FORREST HOUSE

BLOCK 11 SECTION 7 FORREST

DRAWING NO.	TITLE
WA000	PLAN - LOCATION & DRAWING SCHEDULE
WA004	PLAN - DEMOLITION
WA005	PLAN - SITE
WA007	SOFT LANDSCAPE ANALYSIS
WA008	SHADOW DIAGRAMS
WA009	SHADOW DIAGRAMS
WA010	SHADOW DIAGRAMS
WA011	PLAN - AREA GFA
WA011	PLAN - BASEMENT
WA102	PLAN - GROUND FLOOR
WA103	PLAN - FIRST FLOOR
WA104	PLAN - ROOF
WA200	STREETSCAPE ELEVATION
WA201	ELEVATIONS
WA202	ELEVATIONS
WA300	SECTIONS
WA900	STREET PERSPECTIVES

DRAWING TITLE  
**SOFT LANDSCAPE ANALYSIS**  
SCALE  
**As indicated @ A1**

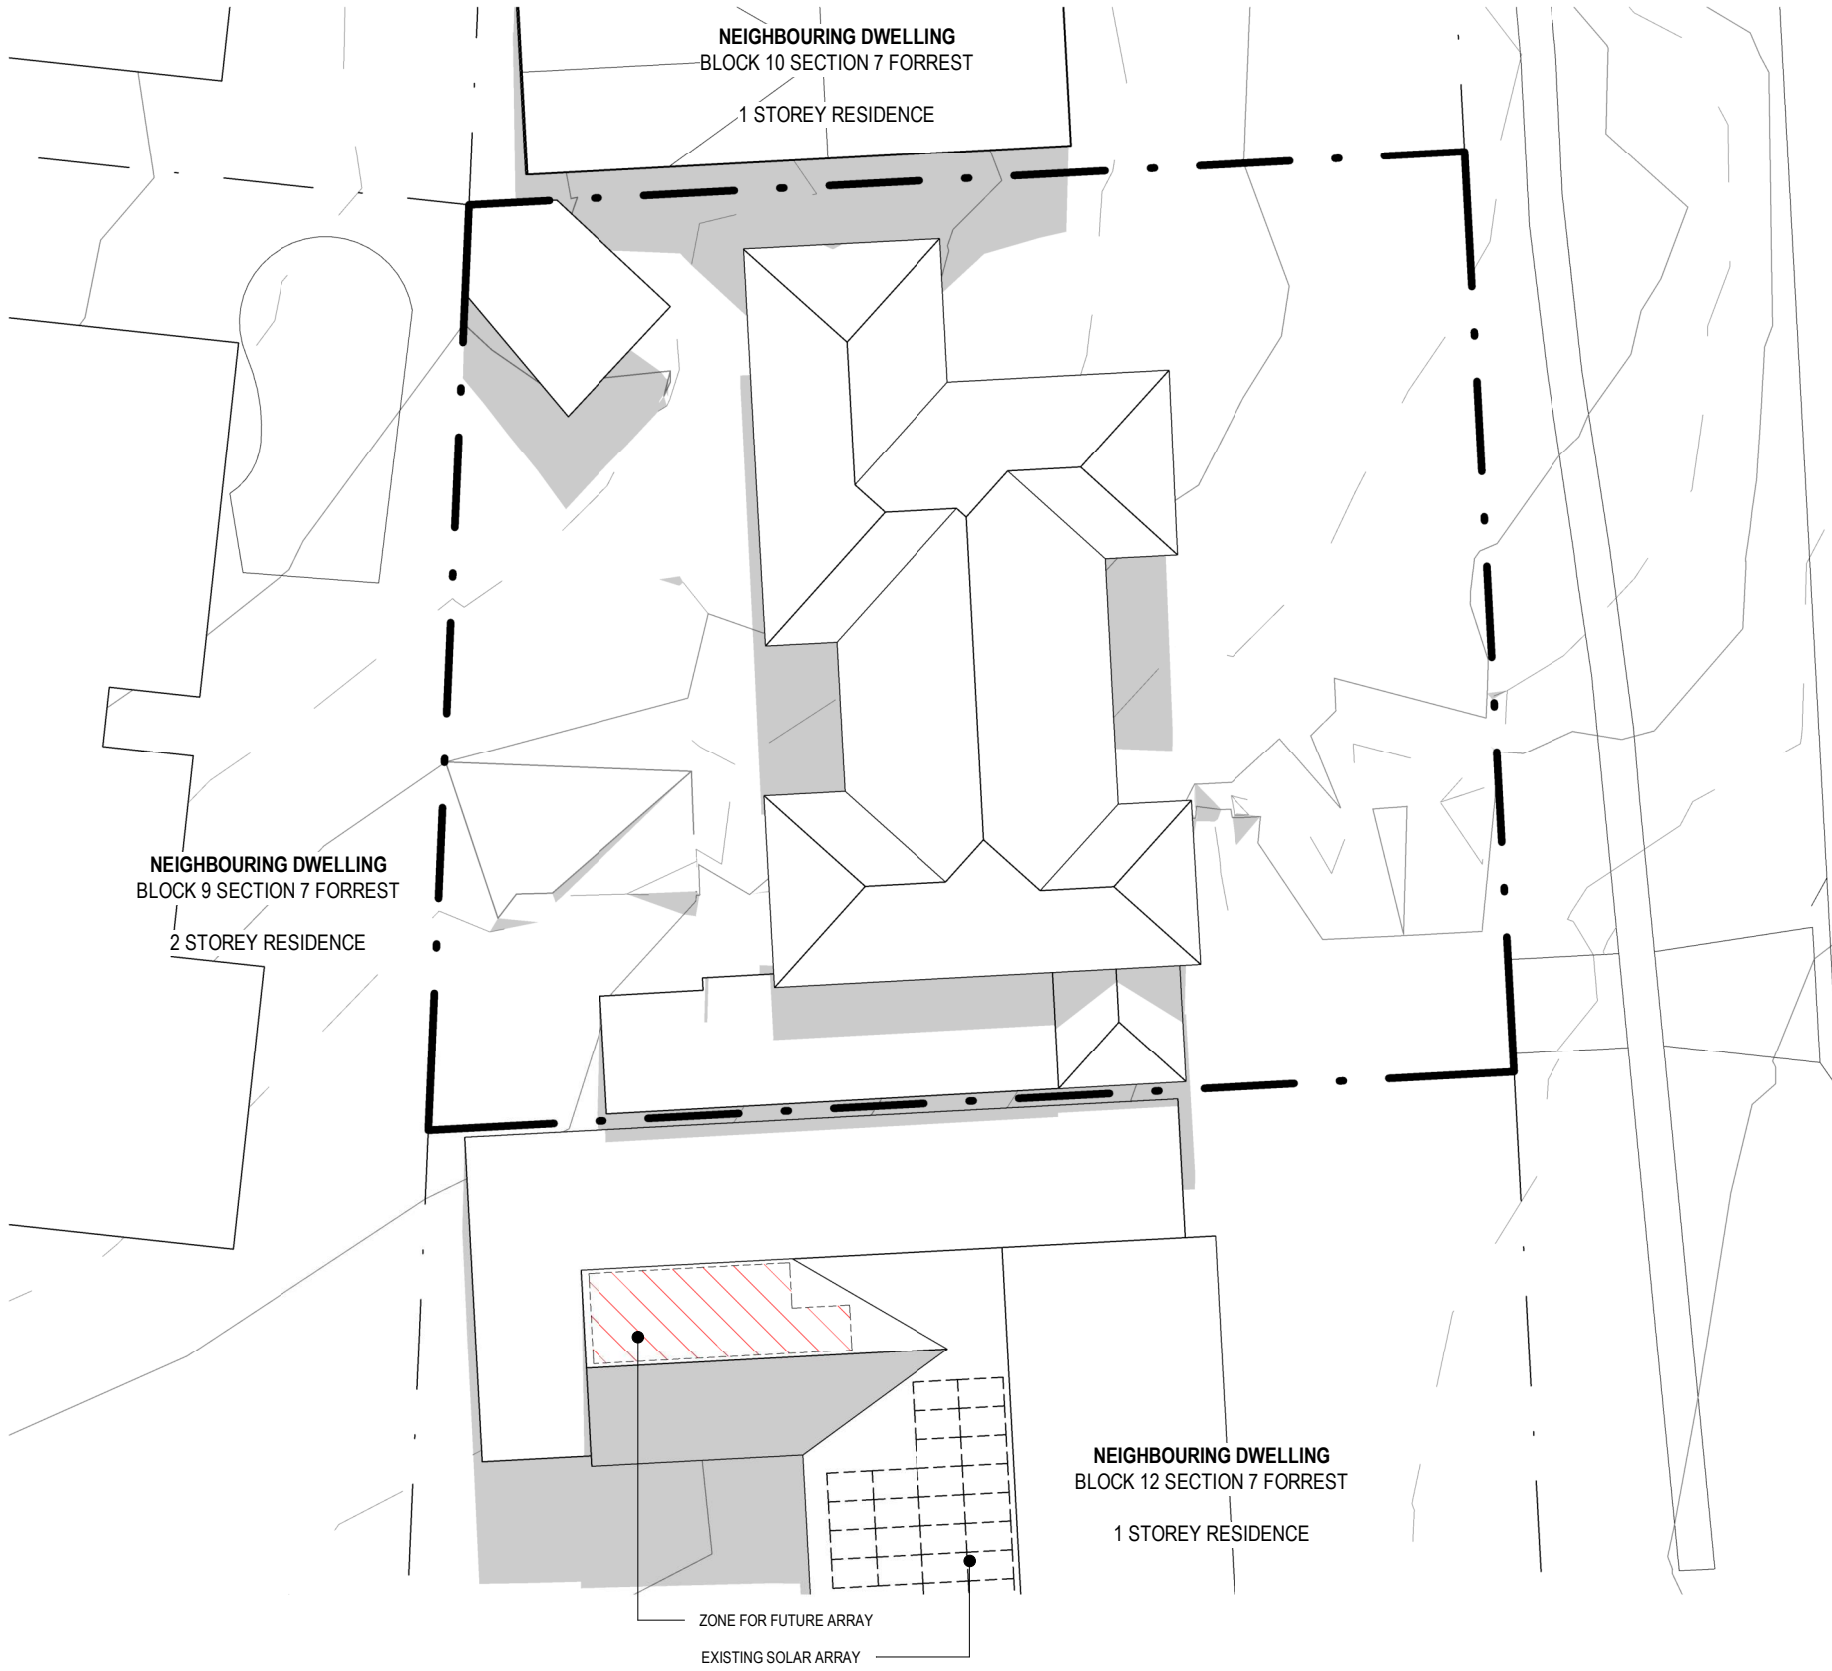
- WORKS APPROVAL - RFI RESPONSE**
- EASTERN WALLS MOVED 240mm WEST TO SETBACK LINE.
  - WESTERN WALLS MOVED 500mm EAST. FACADE ARTICULATION WALL REMOVED.
  - POOL PAVILION WALLS REMOVED. AREA NOW AN UNENCLOSED COVERED AREA. SOFT LANDSCAPING AREA INCREASED, GFA DECREASED.
  - SHADOW EXTENT REDUCED AS A RESULT OF THE BUILDING FOOTPRINT DECREASING. STUDY AND DINING ROOMS INCREASED IN DEPTH. MASTER BED PLANTER REMOVED. SOUTHERN LANDSCAPE ALTERED FOR GREATER VISUAL PRIVACY.
  - FEATURE TREE CENTRED TO MASK VIEWS TO/FROM STAIR.
  - ADDITIONAL PLANTING ADDED TO BOUNDARY WALL.
  - ADDITIONAL LARGER PLANTING ADDED TO KITCHEN PLANTER (REFER LANDSCAPE DOCUMENTS).
